APPLICATION NO.	FILING DATE	FIRST NAMED INVENTOR	ATTORNEY DOCKET NO.	CONFIRMATION NO.
10/681,519	10/08/2003	Peter Tiemann	2001P23807US	9638
7590 02/14/2006			EXAMINER	
SIEMENS CORPORATION			WIEHE, NATHANIEL EDWARD	
INTELLECTUAL PROPERTY DEPT. 170 WOOD AVENUE SOUTH			ART UNIT	PAPER NUMBER
ISELIN, NJ 08830			3745

ϵ				
	Application No.	Applicant(s)				
	10/681,519	TIEMANN, PETER				
Office Action Summary	Examiner	Art Unit				
	Nathan Wiehe	3745				
The MAILING DATE of this communication app Period for Reply	pears on the cover sheet with the	correspondence address				
A SHORTENED STATUTORY PERIOD FOR REPLY WHICHEVER IS LONGER, FROM THE MAILING DA - Extensions of time may be available under the provisions of 37 CFR 1.1: after SIX (6) MONTHS from the mailing date of this communication. - If NO period for reply is specified above, the maximum statutory period of - Failure to reply within the set or extended period for reply will, by statute Any reply received by the Office later than three months after the mailing earned patent term adjustment. See 37 CFR 1.704(b).	ATE OF THIS COMMUNICATION 36(a). In no event, however, may a reply be to the state of the state	ON. timely filed m the mail

Fig. 1

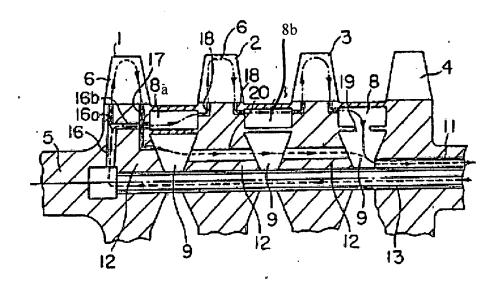
Claims 12,13,15,18 and 19 are rejected under 35 U.S.C. 102(b) as being anticipated by Suenaga (EP 0 806 544). Suenaga discloses a turbine shaft (See Fig. 1

below) including two cooling circuits. Both circuits contain a first region (16a,8a), containing live steam, a second region (6) within a respective blade (1,2) and a third region (9,8b) containing used steam. Each of the blades is provided with live steam for effective cooling and the third regions communicate flow wise with outlet (11). Further, the structure disclosed by Suenaga shows that the third region (9) of the first circuit is sealed from the first region (8a) of the second circuit.
